ATTENTION: GENERAL MANAGER C PARTS MANAGER C CLAIMS PERSONNEL C SERVICE MANAGER C	IMPORTANT - All Service Personnel Should Read and Initial in the boxes provided, right. © 2018 Subaru of America, Inc. All rights reserved. SERVICE BULLETIN	QUALITY DRIVEN® SERVICE
APPLICABILITY: SUBJECT:	2019MY Ascent 2019MY Forester Power Rear Gate (PRG) Control Module- Design Change	NUMBER: 07-143-18R DATE: 11/16/18 REVISED: 05/22/19

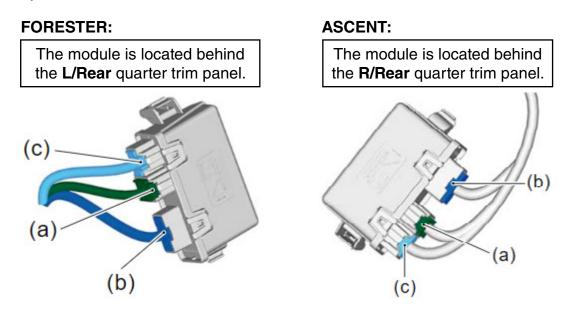
When disconnecting the harness connectors from the module, it **MUST** be done in proper (a) - (b) - (c) sequence / order using the illustrations below as a reference. Otherwise, a DTC may result after the battery is reconnected.
